FINAL PLAT

COTTAGE GARDENS

Re: S/D 90-64 (Final Plat) Cottage Gardens Addition

STAFF REPORT
(Final Plat Approved 4/18/91,
Preliminary Plat Approved 2/21/91)

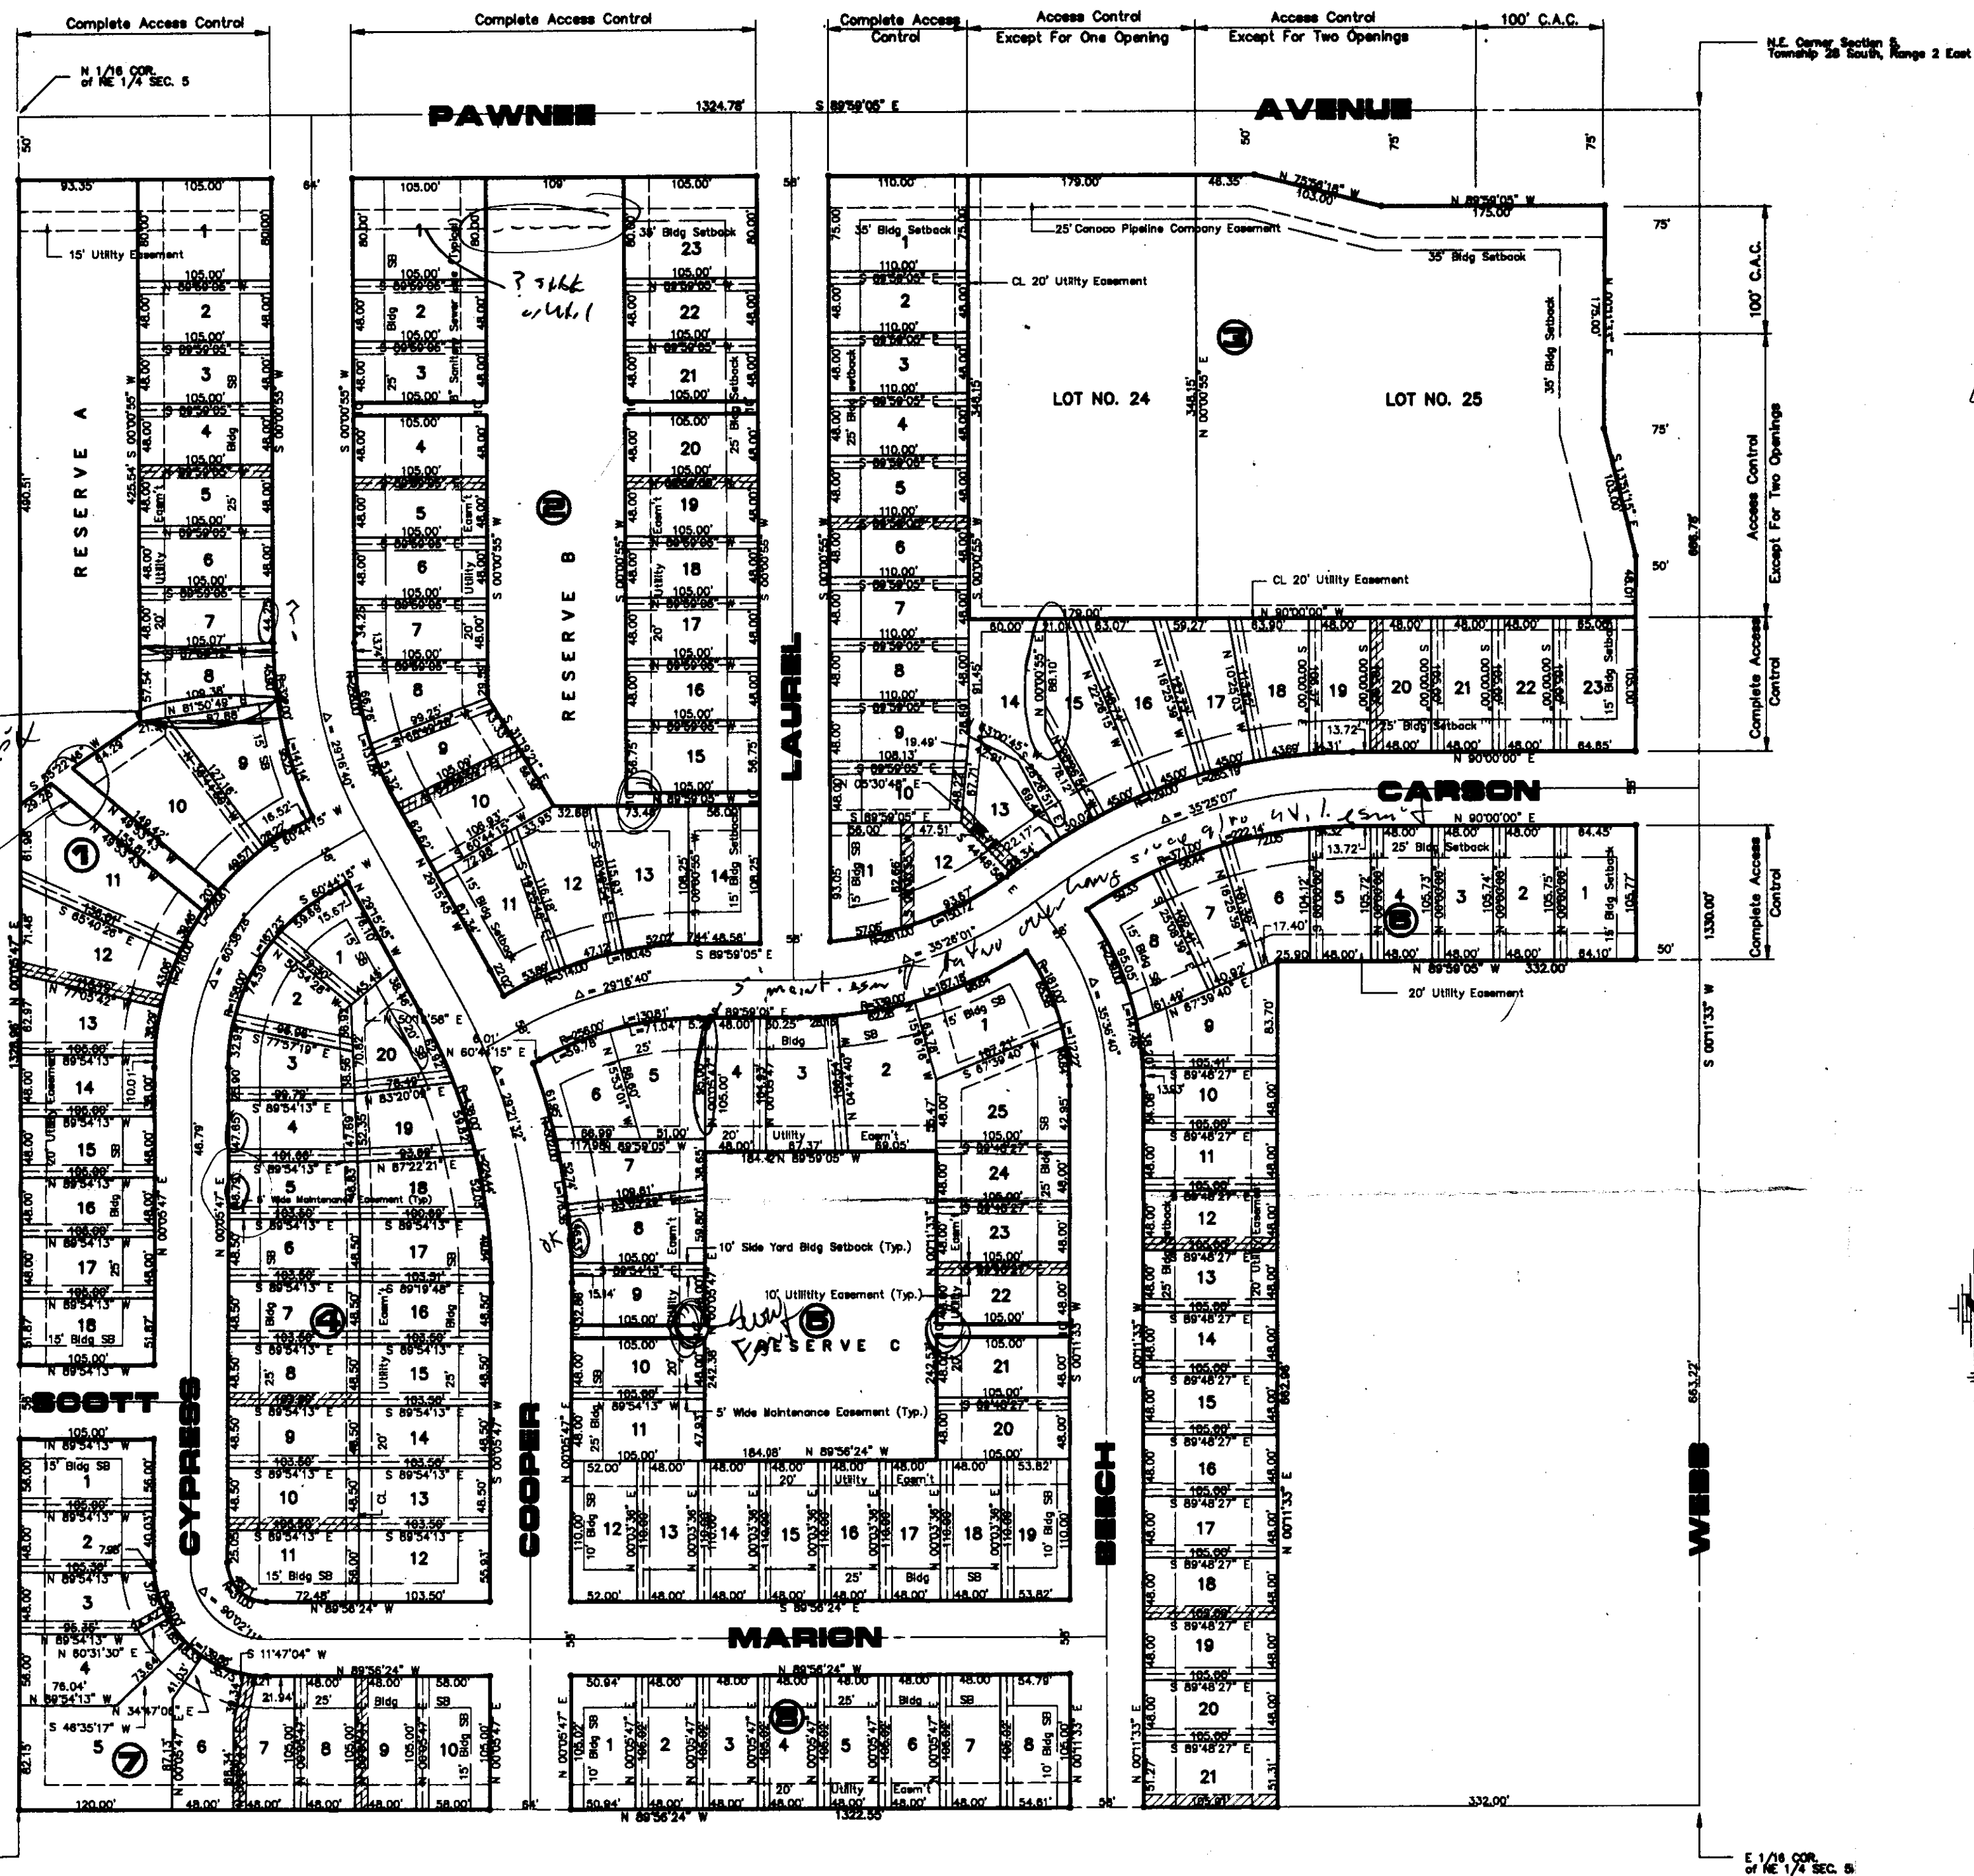
- Z. The utility easement and/or setback along the north line of the residential lots and Reserve B adjacent to Pawnee shall be clearly labeled with the dimension of the setback (35-feet), or of an easement. It shall be clearly indicated as such. In particular if an easement is to cross Reserve B, and shall be shown along the north end of this Reserve and Lots 1 and 23 either side of the Reserve.

- A. Prior to this plat being scheduled for City Council review, both the annexation of this site to Wichita and the recommended zone change to "AA" one-family zoning will need to be approved. This site will be subject to any conditions of the annexation and/or zone change. The applicant is advised that if the "LC" zoning is not changed, the plat will need to be revised so that adjacent streets meet requirements for "LC" property (70-foot right-of-way, 41-foot paving, sidewalks at least along the side adjacent to the "LC" zoning).

- F. The applicant shall guarantee the paving of the proposed interior streets. The paving petitions shall also, as required by the sidewalk ordinance, provide for sidewalks along one side of both Cooper and Carson streets. The applicant may if he desires propose an alternate sidewalk system which substantially provides the same level of service as the required sidewalk system.

M. The final plat shall indicate the recording information for the Conoco pipeline easement on this property.

N. On the final plat, the center lines (CL) of Webb and Pawnee shall be labeled.

O. Because of the use of 10-foot sideyard setbacks required for zero lot line development, certain corner lots will be very limited in the buildable area available when a typical 15-foot sideyard setback is also required. It is recommended therefore that a 10-foot sideyard be allowed for a corner lot in cases where the building area would be less than the typical 38 foot areas of the majority of the lots. For example, Lot 8, Block 8 and Lot 19, Block 2 would only have a 30-foot width for building.

P. The present print on the final plat, particularly the dimensions, bearings, size of easements and setbacks, etc. on the face of the plat, are too small for microfilming and are of a size not accepted by the Register of deeds for recording a document. The

- Q. Except when located on a corner, lot frontages at street right-of-way should meet the minimum standard. For this cluster development a 48-foot frontage should be maintained unless physical constraints can be identified. In particular, Lot 7, Block 1 and Lots 4 and 5, Block 4 should be able to conform to the 48-foot minimum frontage by the shifting of lot lines of adjacent lots.

- R. On Lot 15, Block 3, the maintenance easement and zero foot sideyard setback should be continued along this lot's west line in order to allow Lot 14 to use the zero lot line option in the buildable area of this lot. If lot 13 of this Block is also intended to be used for a zero lot line home, a maintenance easement and sideyard setback should be shown along the southwest line of Lot 14.

- S. For Lot 4, Block 5 a zero lot line could be allowed if a 5-foot maintenance easement is shown along Lot 5, within the utility easement. However, no roof overhang should be allowed where an overlapping utility easement is also present. Consequently, the platting text would need to be amended to indicate that the roof overhang would not be allowed if the 5-foot maintenance easement was also located in a utility easement.

- T. On the final plat tracing, where utilities are crossing the Reserves, such as along the north line of Reserve B, the south line of Reserve A, and the two entrances to Reserve C, utility easements shall also be clearly indicated as crossing these Reserves.

- U. Easements were requested by the Utilities between: Lots 2 and 3, Block 4, Lots 19 and 20, Block 4 and Lots 4 and 5, Block 6. These easements shall be indicated on the final plat tracing.

- V. On the final plat tracing an insert of an enlarged area of lots shall be provided to better indicate the platting of the 5-foot maintenance easement, 10-foot sideyard setback and in certain cases the overlapping utility easements.

- W. On the final plat tracing the word "Acting" shall be deleted from the MAPC signature block.
- X. The applicant is advised that the buildability of Lot 10, Block 3 is questionable. A 10-foot easement and a 10-foot sideyard setback will leave a buildable width of 28-feet for this lot.

- Y. Unless a maintenance easement and sideyard setback are platted on Lot 5, Block 7, this Lot could only be developed for a conventional or non-zero lot line home
